G.O., No. 617 M

Recording letter from the President, Municipal Commission, Madras, submitting the report called for in G.O., No. 1870 M., dated 8th November 1895, sanctioning the sale of certain plots of --- in the municipality.

Informing with remarks
the Chairman, M.C. Conjeverso
that all new — should
be constructed on the
approved pattern & that
the existing open space
Catruines should be gradually
closed by others on the
approved plan.

Furnishing information called for in g.o. No. 275 m. his dated 15th February 1896 with reference to the latrine erected by the Cojaveeram Municipality.

STANDARD PLAN
OF A DOUBLE
IRON LATRINE

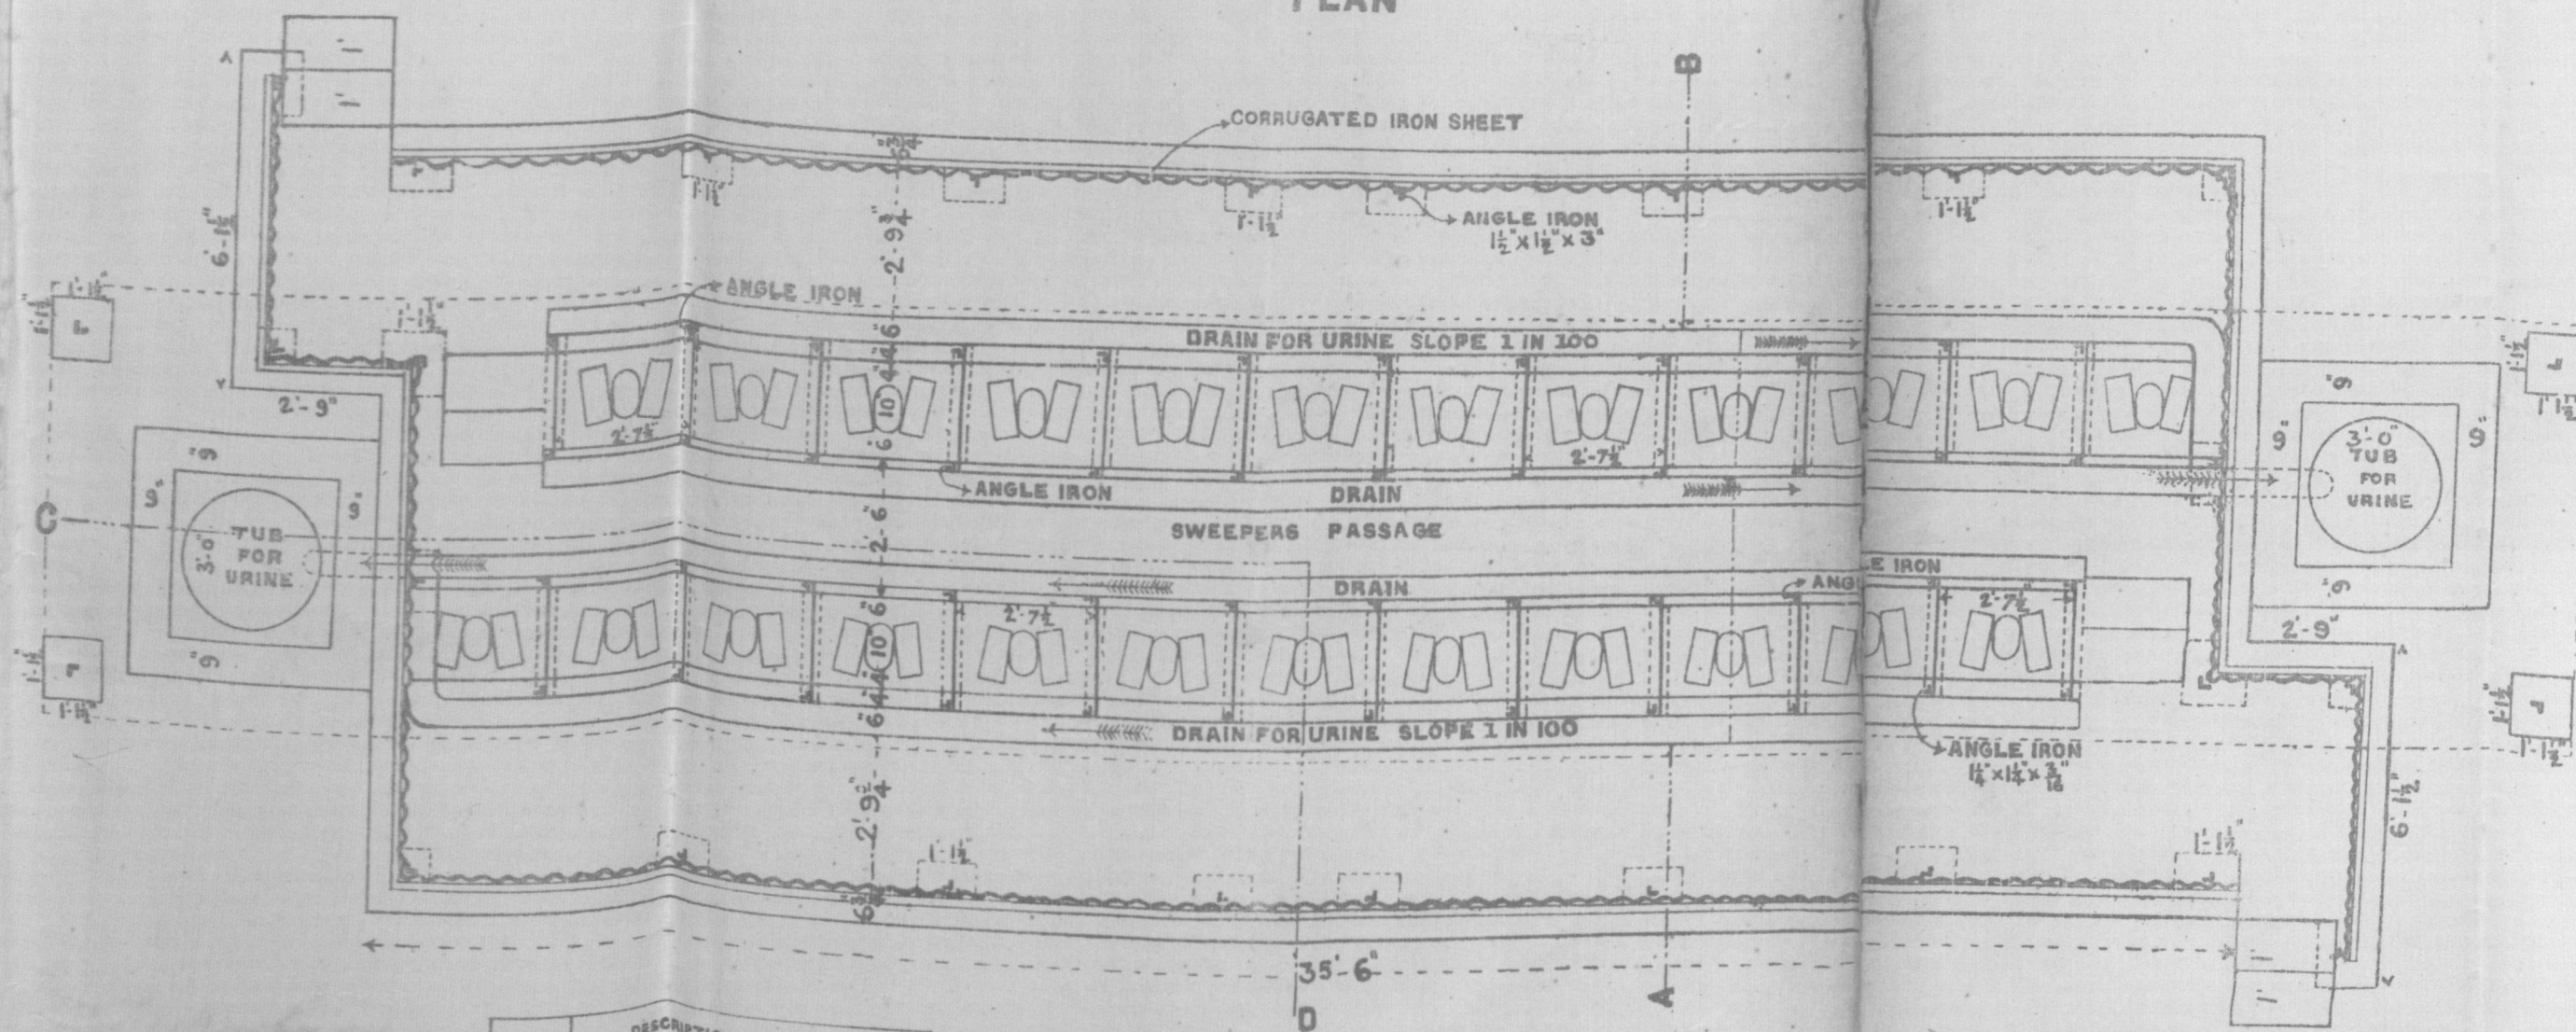
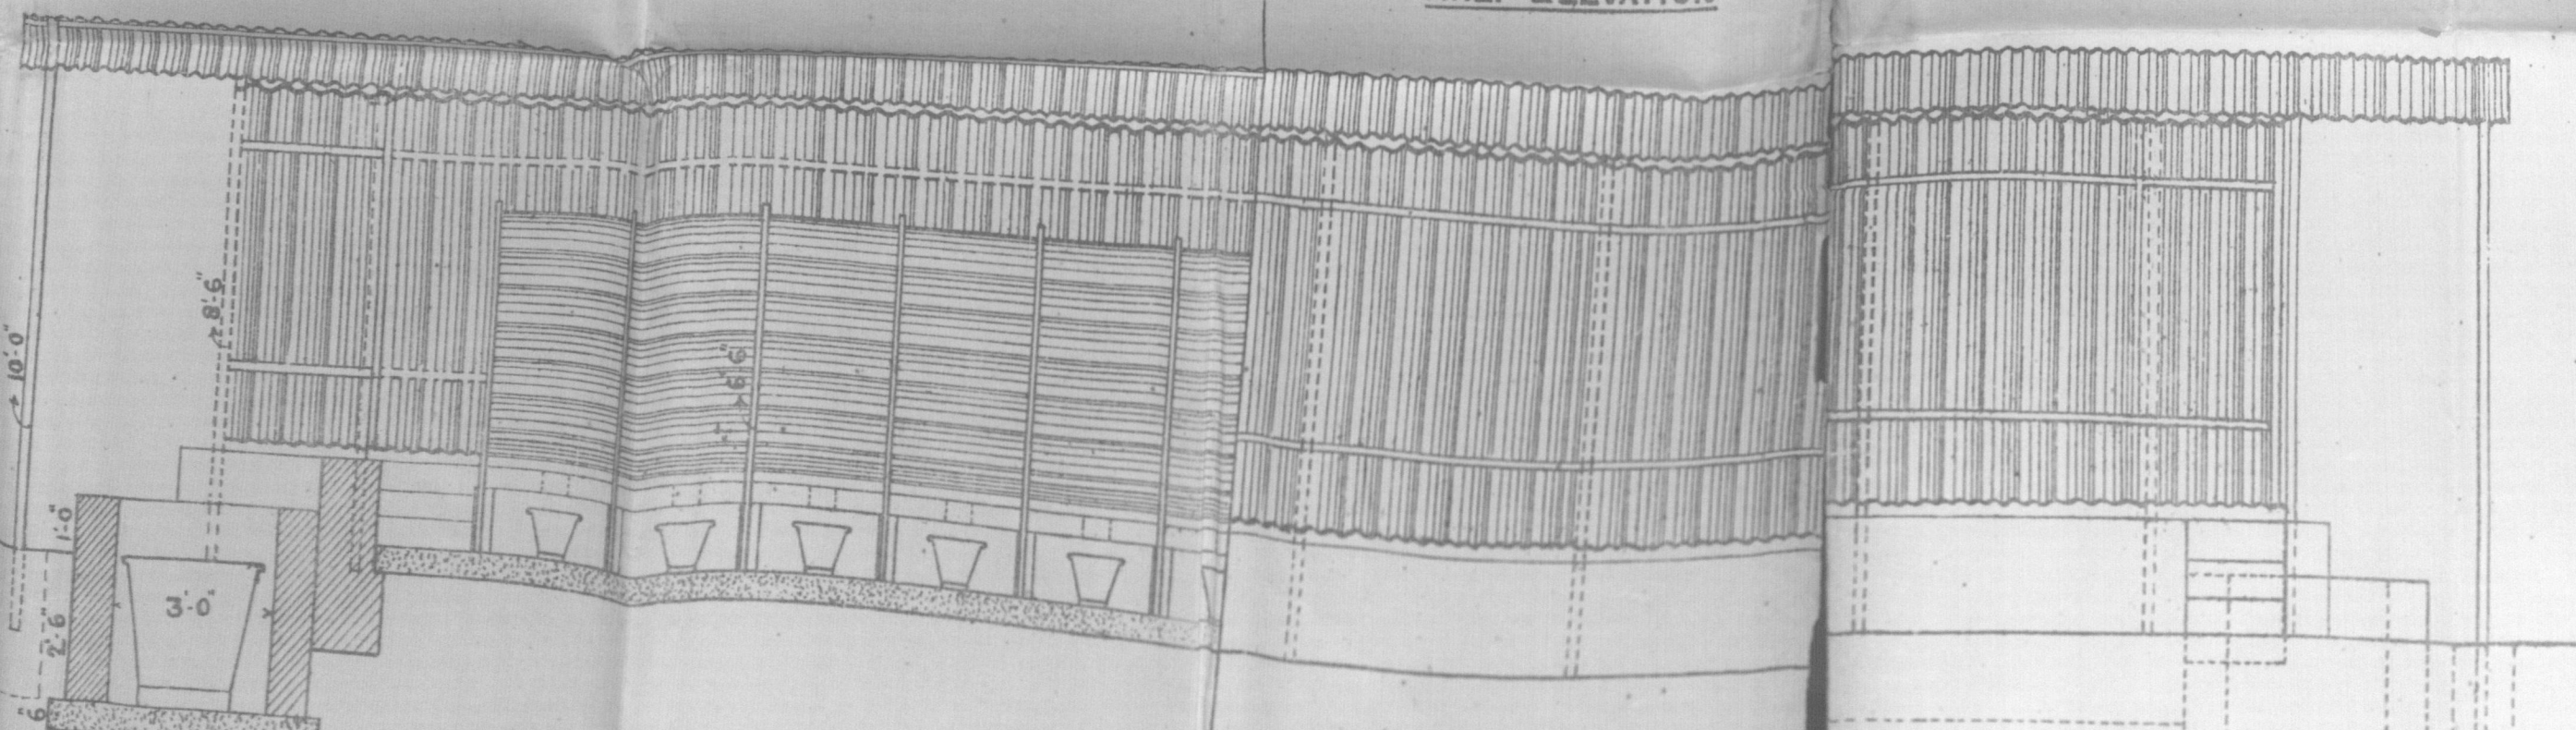
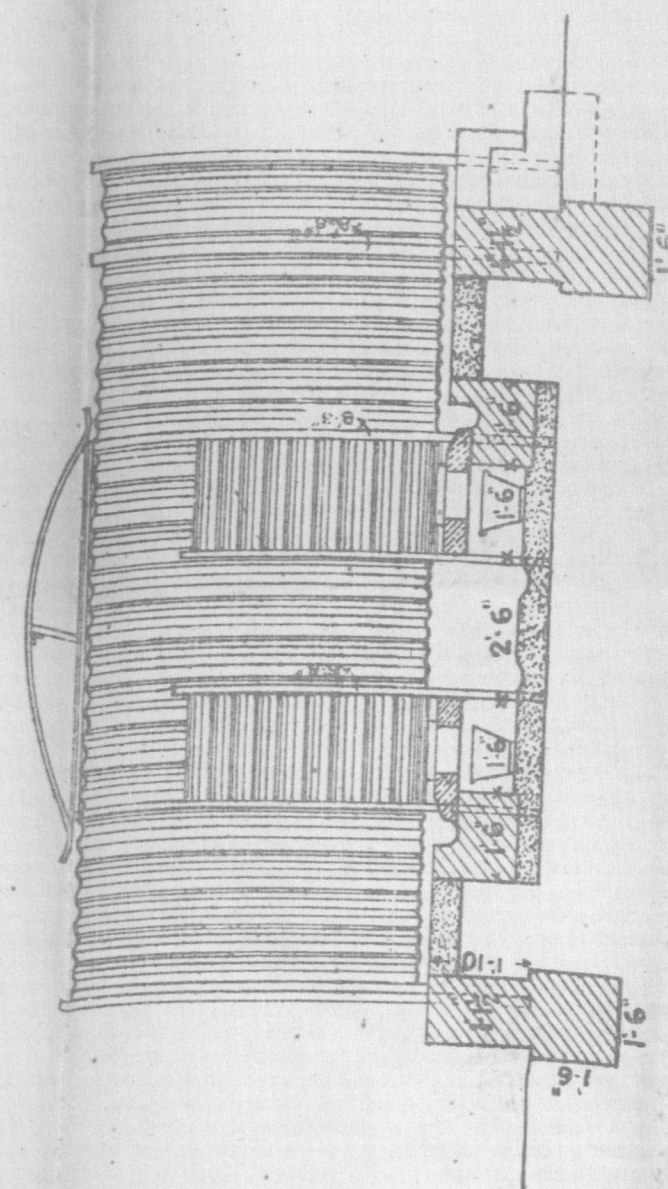
With reference to G.O. N^o 275 M. No. dated
15th February 1896 (my reply to which has been delayed
because of the non receipt from the Bangalore Municipality
of the plan of the latrine they had erected) I have the honor
to inform you that when the plan of the latrine is received with
G.O. N^o 462 M. dated 5th April 1896, came before the
Sanitary Board, the Board did not approve of it
and required it to be amended. It, since, has been so
and was issued; a copy is attached. It will be seen
that the latrine is now roofed and instead of having
a gravel floor, the floor is flagged - hence the excess cost.
The estimate is Rs 400.

The plan, the Council refer to, is latrine
design N^o 4 also attached which is a more expensive plan.

A plan of the latrine erected by the Congeervann Municipality is also enclosed. It is a mere enclosure which cannot be provided owing to its size, with an impervious floor except at considerable cost & the Sanitary Board require latrines to be roofed.

The corrugated iron sheets of the latrines already erected can be utilized in erecting latrines to an approved plan.

The municipal council is re-quest that it may be permitted to construct ^{open} ~~enclosed~~ latrines, ⁱⁿ ~~in~~ ^{the} ~~the~~ ^{of} ~~of~~ those of the standard plan approved by the Sanitary Board, cannot be complied with. From the Sanitary Engineer's letter read above, however, it appears that the estimated cost of a closed latrine, as recently revised by the Sanitary Board, is only Rs 400. The Council should therefore see that all new latrines, constructed by it ^{on} ~~of~~ this pattern, and ^{to} ~~to~~ ^{gradually} ~~replace~~ the existing ^{open space latrines} ~~latrines~~ by others on approved plan.
